DECISION, CONDITIONS, FINDINGS OF FACT AND CONCLUSIONARY FINDINGS OF THE MCMINNVILLE HISTORIC LANDMARKS COMMITTEE FOR THE APPROVAL OF A NEW BUILDING AT 118 NE THIRD STREET WITHIN THE DOWNTOWN DESIGN AREA

DOCKET: DDR 4-19 (Downtown Design Review for New Construction including Waiver Requests)

REQUEST: Approval of the exterior design of a new building to be constructed on the subject property. The proposal includes the demolition of the two existing First Federal buildings that are located on the property today, the construction of a new building oriented towards the corner of Baker and Third Street, and the reconstruction and reconfiguration of all of the parking lots and drive aisles on the property. As part of the review of the building design, the applicant is requesting waivers from the following 5 (five) downtown design standards:

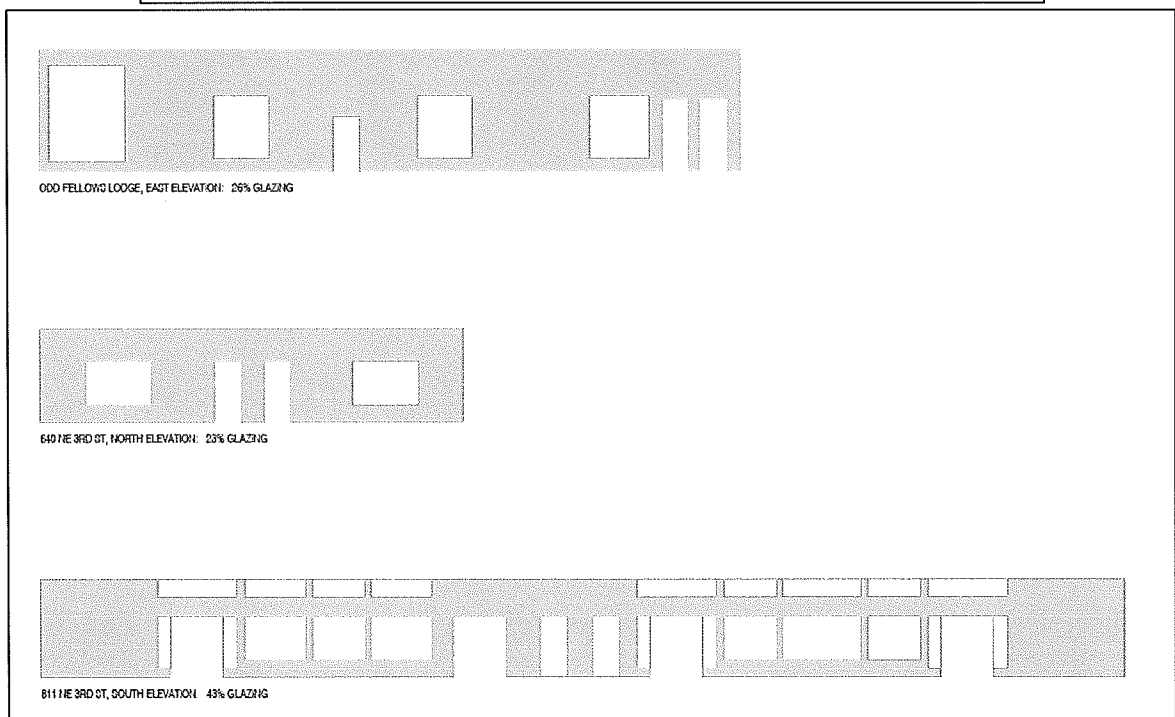
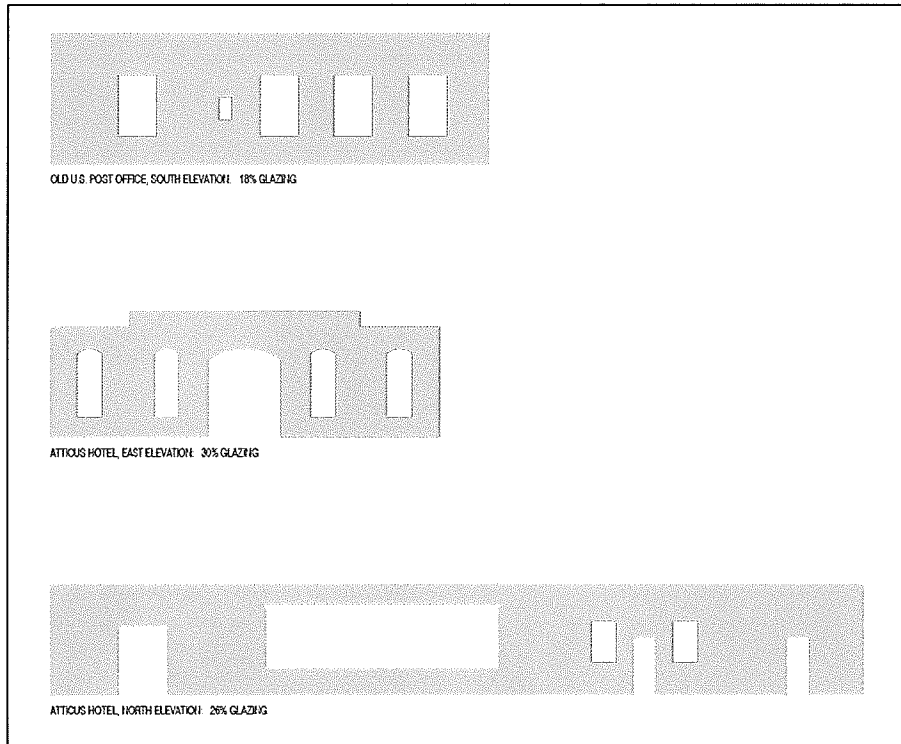
Third Street does not interrupt the retail experience that dominates the Downtown District along Third Street, primarily between Baker Street and Galloway Street. This project establishes its own presence at street level and would continue the varied but historical pattern of the downtown district.

FINDING: SATISFIED. The City concurs with the applicant’s findings. The City adds that the applicant provided an analysis of the glazing percentages of other buildings within the Downtown Design Area, and identified that the proposed glazing for the new building is consistent with those glazing patterns. This analysis of example buildings is provided below:

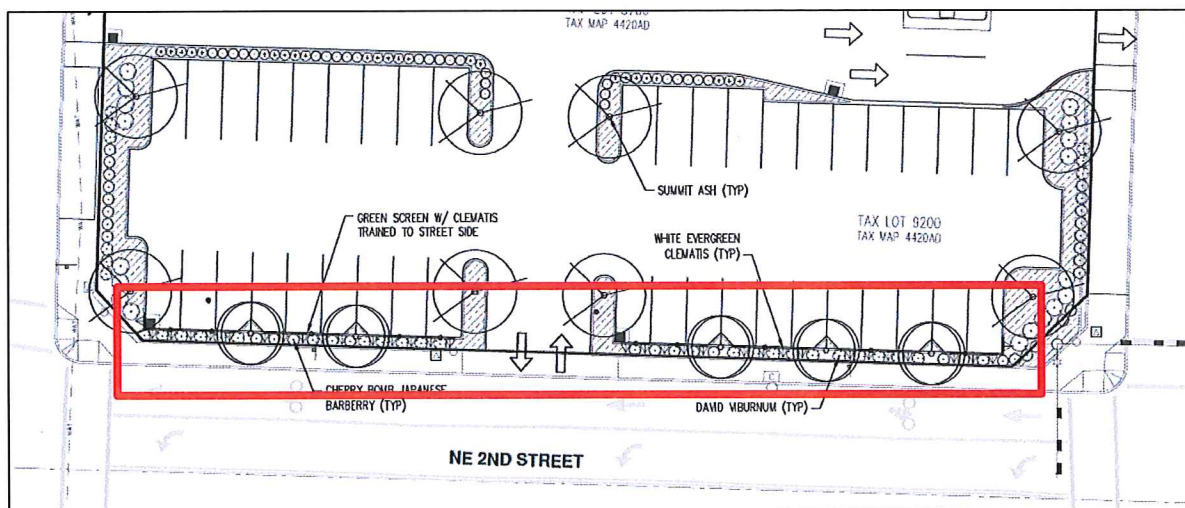
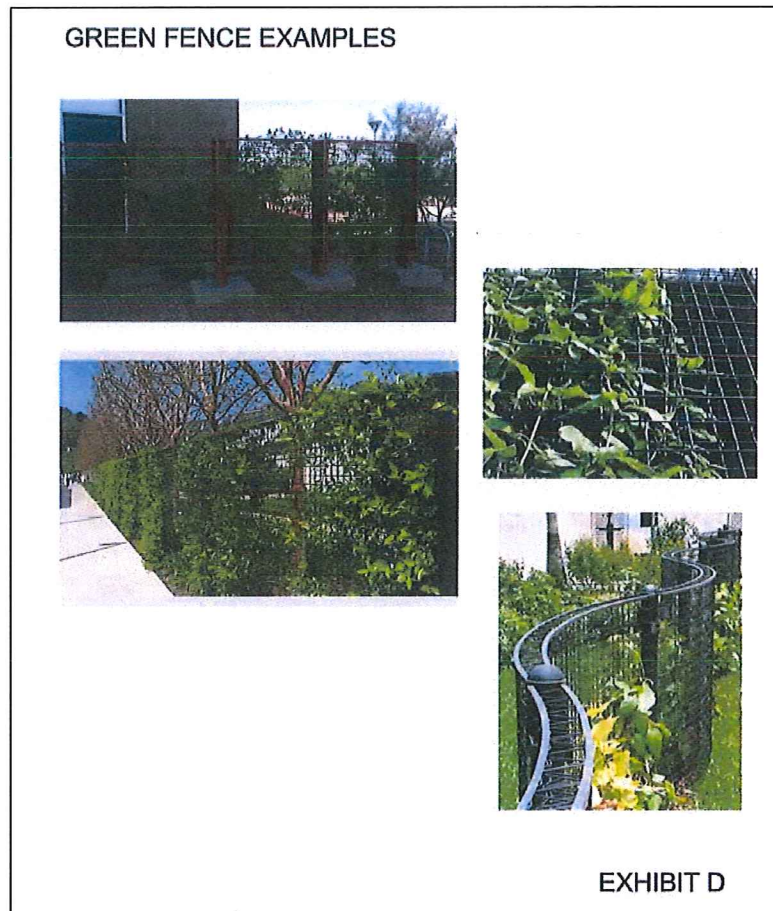
Additional Applicant Response from Supplemental Submittal: Applicant believes it has adequately addressed and has met the circumstances necessary to support this waiver. See pages 12-14 of Applicant's Land Use Application Revised August 01, 2019. Applicant would again stress the significant numbers of employees, and also customers who use these parking lots and drive extended and four door pickups which require significant maneuvering space.

FINDING: SATISFIED. The City concurs with the applicant's findings. While some reductions in drive aisles could have been pursued to allow for the 5 foot landscape buffer per Section 17.60.080(G), the City finds that the alternative design proposed by the applicant accomplishes the purpose of the Downtown Design Standard Chapter, as described below.

The site plan identifying these proposed setbacks and projections is provided below:

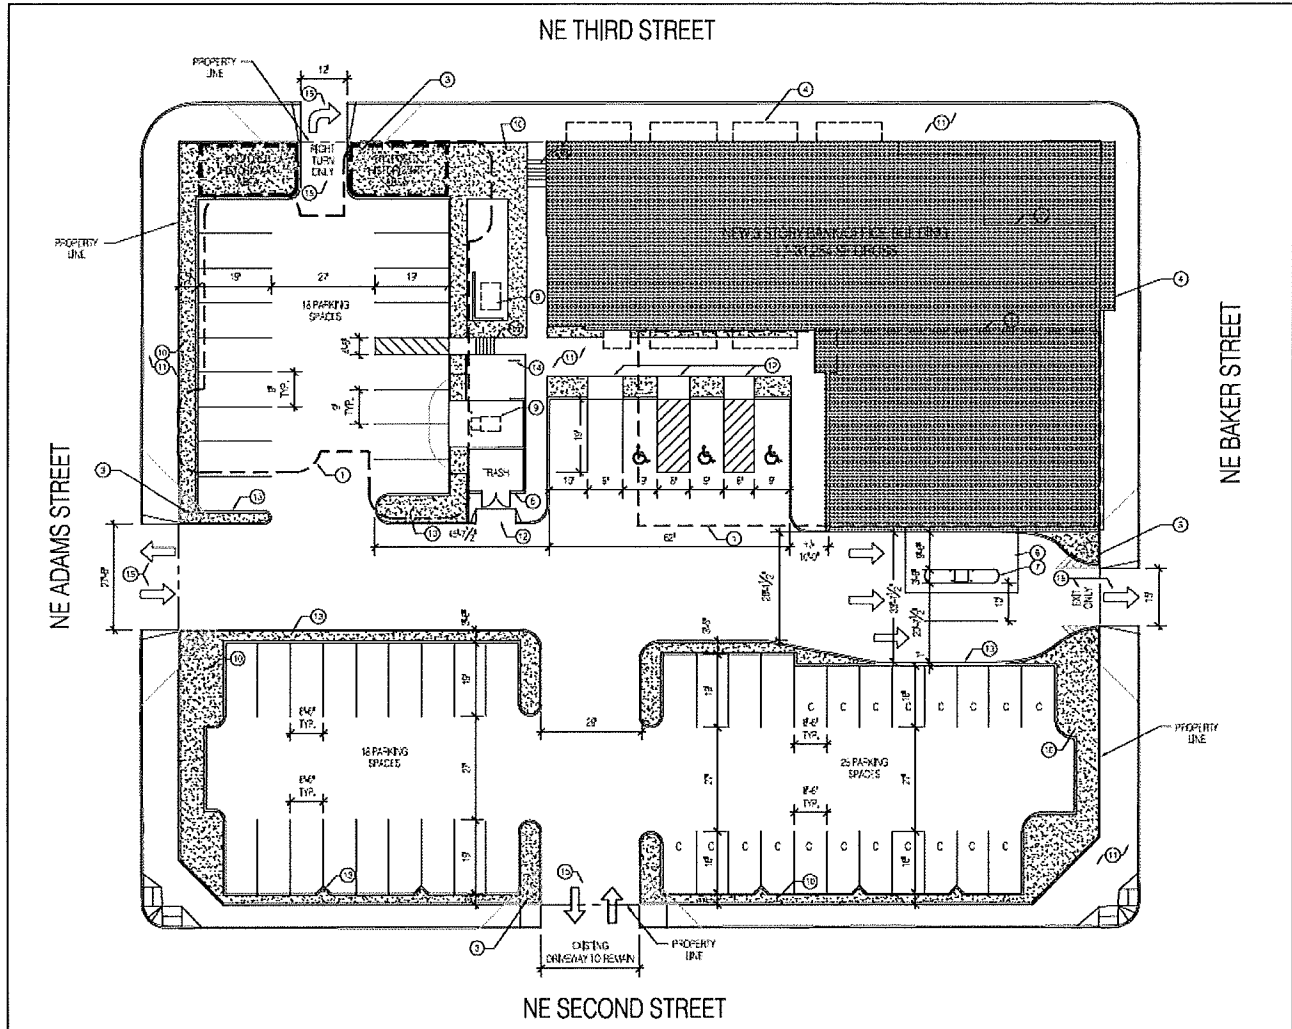
FINDING: SATISFIED WITH CONDITION #3. The City concurs with the applicant's findings. The City adds that the proposed site plan for the building and development show construction of the new building with zero setbacks along the majority of the NE Baker Street and NE Third Street property lines. The only portions of the ground floor building wall that are not constructed to the property lines is the area that is recessed for the main entry and a plaza space in front of the entry, and smaller areas along the Third Street and Baker Street facade. Along the Third Street façade, only 22 feet of the overall 142 feet of building frontage are slightly set back from the property line. This portion of the façade is setback 3 feet from the property line, and allows for a wider pedestrian space adjacent to the recessed entry at the corner of Third Street and Baker Street. Along the Baker Street façade, the ground floor façade is setback approximately 1.5 feet to again allow for a wider pedestrian space. The upper stories of the building along the Baker Street façade are constructed with a zero setback.

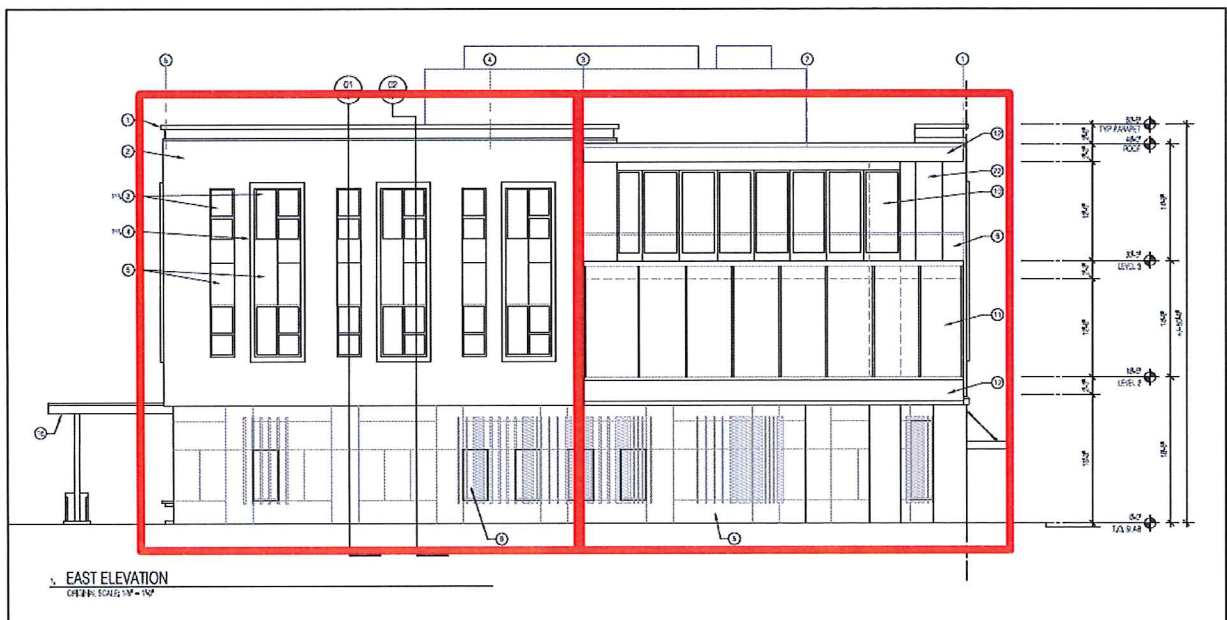
APPLICANT’S RESPONSE: The building elevation along Third Street is divided into three separate sections to provide relief and interest similar to the pattern of the approximately 60-foot subdivisions along NE Third Street to the east. The NE Baker Street elevation is also reduced to separate sections that reduce its scale. We believe these architectural details meet the intent of the design criteria.

FINDING: SATISFIED. Staff concurs with the applicant’s findings, and notes that this property has underlying historically platted lots from Block 3 of the original McMinnville Town Plat recorded on July 3, 1865. Those lots have since been re-described as the three parcels of various configurations that exist on the subject site today.

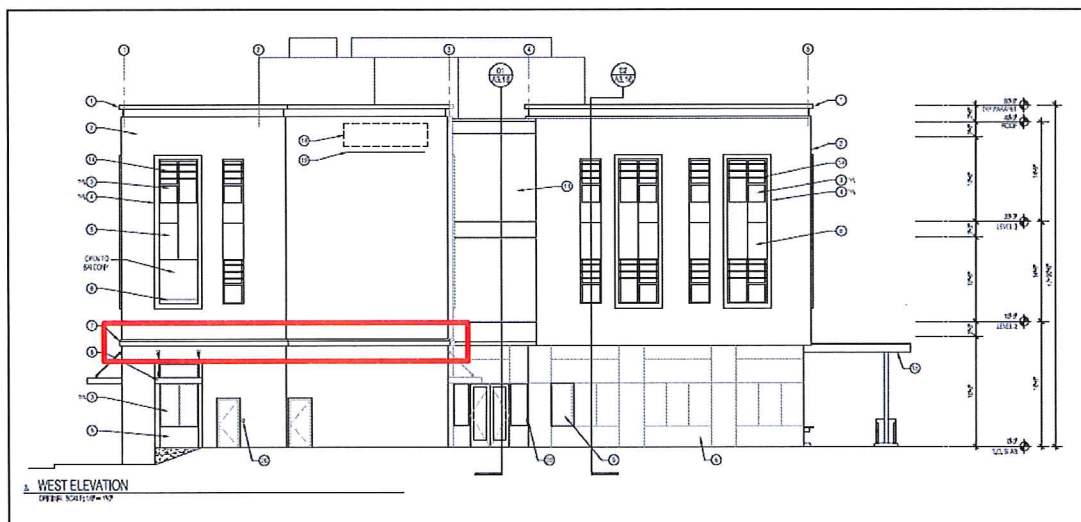
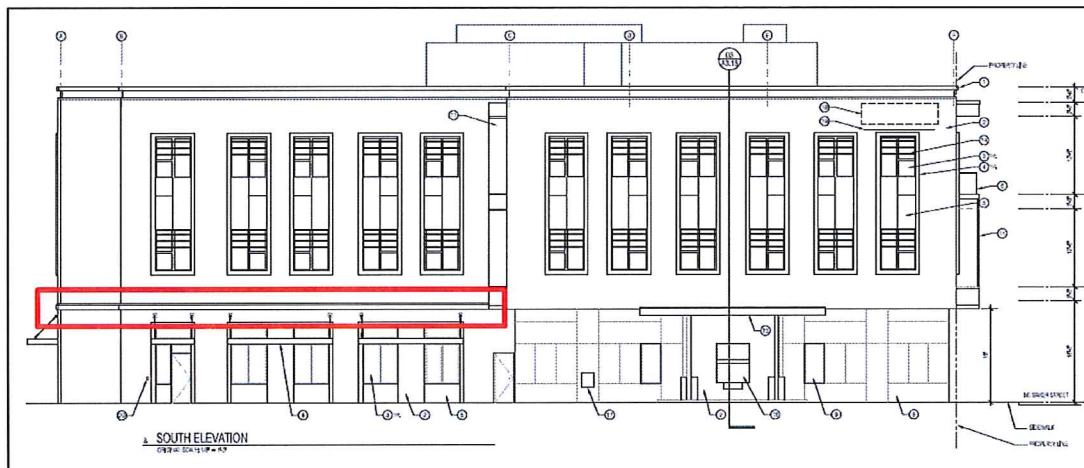
APPLICANT’S RESPONSE: The building has a precast-concrete belt course along the partial north and south facades and along the entire west façade. To continue this architectural feature,

the remaining part of the facades have a brick soldier course aligned with the precast belt course. This belt course is approximately 15 feet above the first floor. We believe these elements meet the intent of the design criteria.

This discrepancy between the elevation drawings and the renderings can be seen below:

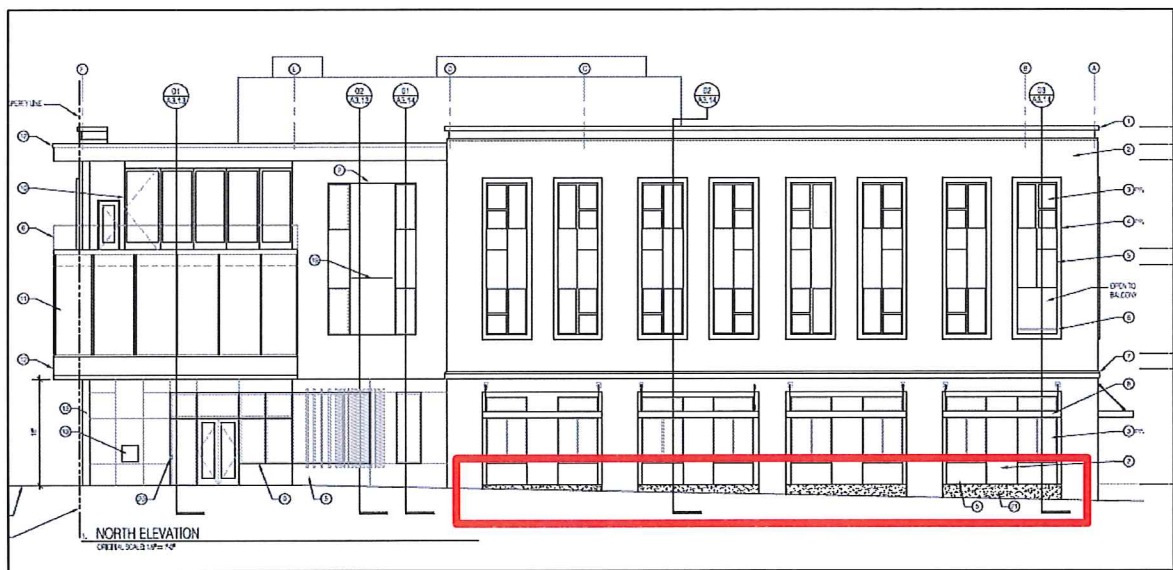
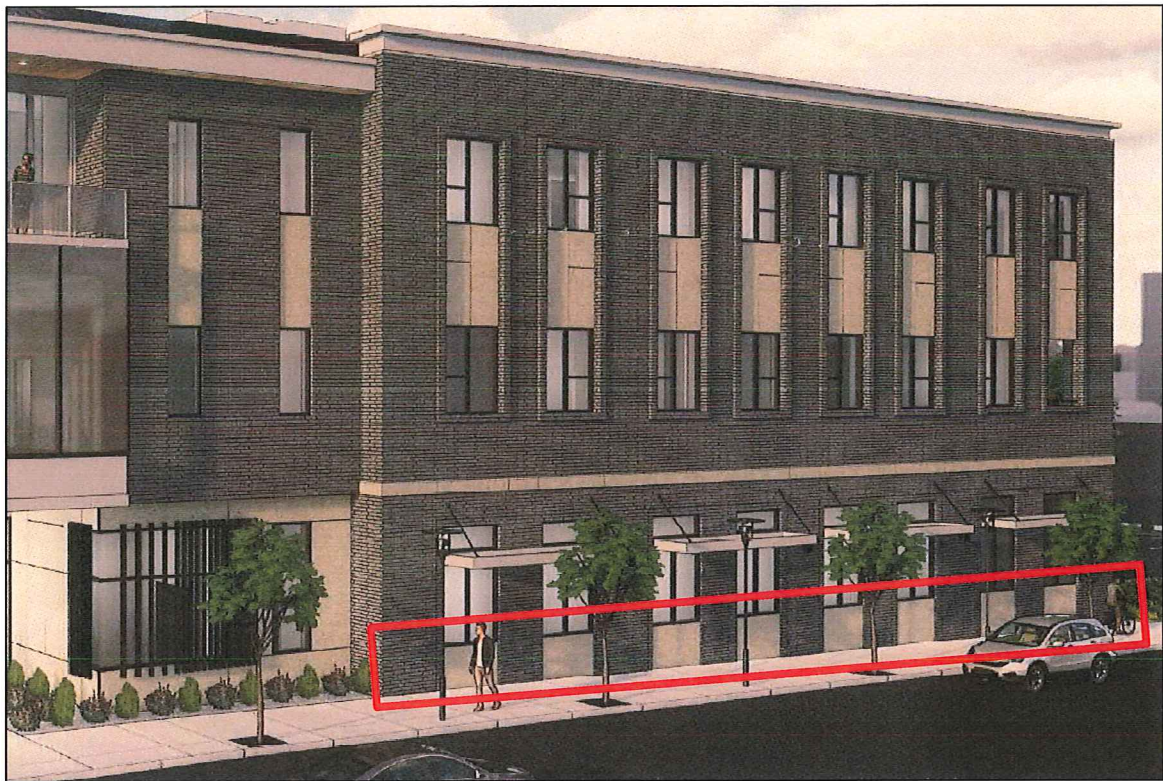
The City finds that the proposed color of the brick material is too dark and too close to the black color that is prohibited. Therefore, a condition of approval is included to require that the applicant provide a revised example of the brick material, and the proposed grout color, for review and approval by the Historic Landmarks Committee. The condition specifies that the color of the revised example brick material shall be a lighter color than the brick material that was originally proposed.

One portion of the façade that is identified differently in the elevation drawings and the renderings is the exposed foundation beneath the windows on the western portion of the 3rd Street façade. This portion of the façade is identified in the elevation on Exhibit C9 as “Exposed Foundation Wall, Skim Coat”, but shows up in the renderings as a consistent material beneath the windows to the sidewalk. The applicant has verified that the elevation drawing is correct, and that the exposed foundation wall would be visible in these areas of the façade, and finished with the cement plaster that is similar to smooth stucco. In order to maintain a cohesive finish beneath the windows and for consistency in this area that is described as the bulkhead in other areas of the application narrative, a condition of approval is included to require that the skim coated exposed foundation wall be painted a tan color to match the stone panels that will be installed above the exposed foundation wall and beneath the windows. Alternatively, the applicant may install the stone panel material over the foundation wall to encompass the entire area from the bottom of the window to the sidewalk.
